Modification Bulletin

MB Correction

Model: I/K Kit Type D for Azalea Da			Date	e: 15-Apr-97	No: 1	
Modified Article: Parts Catalog			Prepared by: A.Sasaki			
From: QAC 1st Field	d Information Dept.					
Reason for	□ Parts catalog correction	correction			To meet standards	
Modification:	☐ To facilitate assembly	\square To improve reliability $\qquad (\qquad)$				
	☐ Part standardization	Other

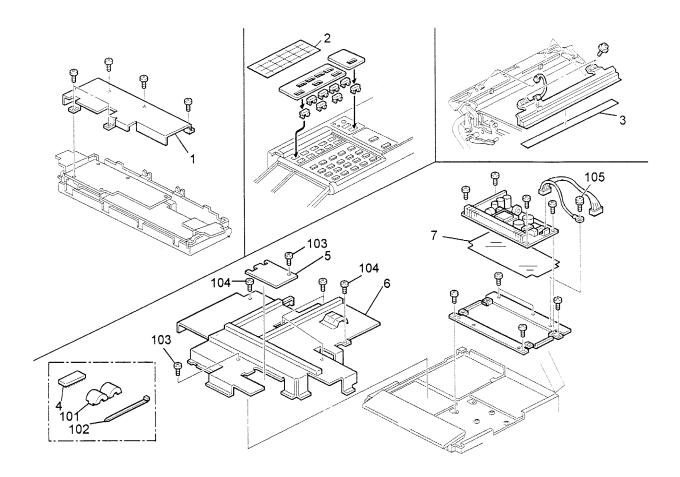
Please add the following parts and the illustrations to your parts catalog.

Old P/N	New P/N	Description	Q'ty	Parts C	Catalog	Reason
			Used	Page	Index No.	
	A6241221	EXU Shield Cover - Basic	0 → 1		1	To meet the EMI standard
	A6241306	Decal : Guidance	0 → 1		2	For other languages
	A1666164	Seal - PTL	0 → 1		3	P/C Correction
	A6245092	IC - Printer	0 → 1		4	P/C Correction
		(IC No. 238)				
	A6241215	Shield Cover	0 → 1		5	To meet the EMI standard
	A6241213	EXU Shield Cover - Edit	0 → 1		6	To meet the EMI standard
	AA150676	Sheet	0 → 1		7	P/C Correction
	16070623	Ferrite Core - TFC- 16-8-13	0 → 1		101	To meet the EMI standard
	11050042	Wire Band	0 → 2		102	To meet the EMI standard
	03140060B	Philips Pan Head Screw - M4x6	0 → 2		103	To meet the EMI standard
	03130080B	Philips Pan Head Screw - M3x8	0 → 2		104	To meet the EMI standard
	08010149	Philips Pan Head Screw - M4x6	0 → 1		105	To meet the EMI standard
